NOTICE OF **REVISED** DECISION

Oaks Village Apartments

Land Use Application Nos.:	SPR 21-007 (Site Plan Review) SEP 21-006 (SEPA) CAP 21-001 (Critical Areas Permit)
Applicant:	AKS Engineering
Property Owner:	Pat Jeffries 41 st Ave LLC
Site Location:	Green Mountain Road & Green Mountain Loop
Parcels:	Apartments: 508630100 Road: 508610100, 508620100, 508650100, 508680101, 508680100, 508690100, 508720100
Size:	3.69 Acres
Zoning Designation:	Medium Density Residential (MDR)
Date Application Received:	July 1, 2021
Fully Complete:	July 28, 2021
Notice of Application & Likely DNS issued:	August 2, 2021
Comment Period & SEPA Appeal Period Ended:	August 18, 2021
Notice of Decision Issued:	October 26, 2021 REISSUED November 3, 2021
DRC Decision:	Approve with Conditions

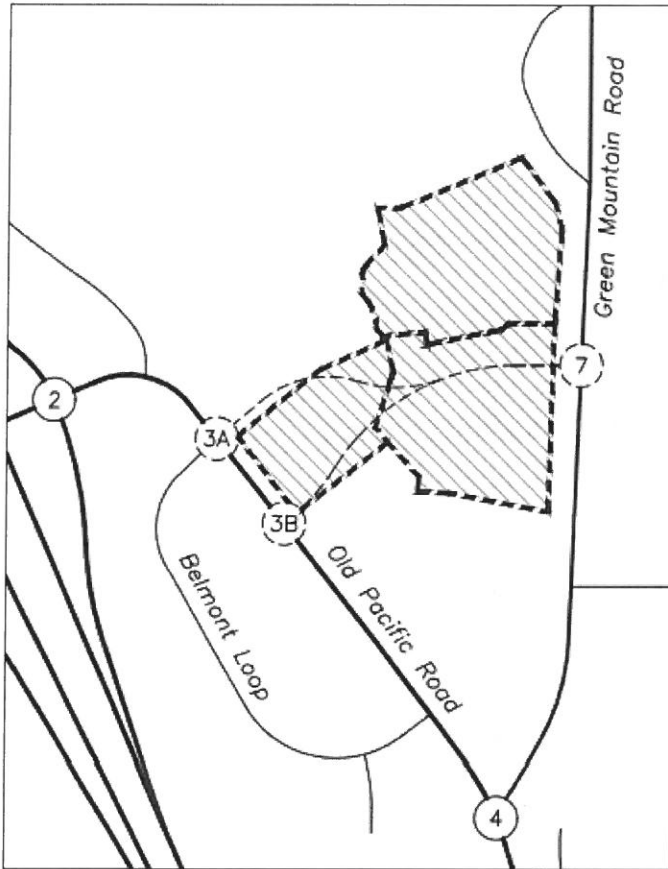
Finding 6: (Was Finding #4) The applicant's site plan shows an alignment for the proposed Burriss Lane that will not allow for the construction of an intersection (3A) with Old Pacific Highway that meets City standards. The Burriss Lane alignment will need to be adjusted such that it intersects with Old Pacific Highway at a right angle at a location to the south of Wetland D. This alignment is shown conceptually in the submitted Traffic Impact Analysis dated June 16, 2021, in which it is given the designation 3B. (See below)

5. The final alignment for Burriss Lane will be shifted from the 3A alignment to an alignment similar to the 3B alignment. The final alignment shall be shown as part of the final engineering approval for the phase that includes the majority of Burriss Lane, or with future land use and engineering approval for development on the properties to the south. A left-turn lane on southbound Old Pacific Highway shall be included with the construction of Burriss Lane. Submit an updated site plan with the final engineering submission or provide a new site plan submittal for the updated road location.
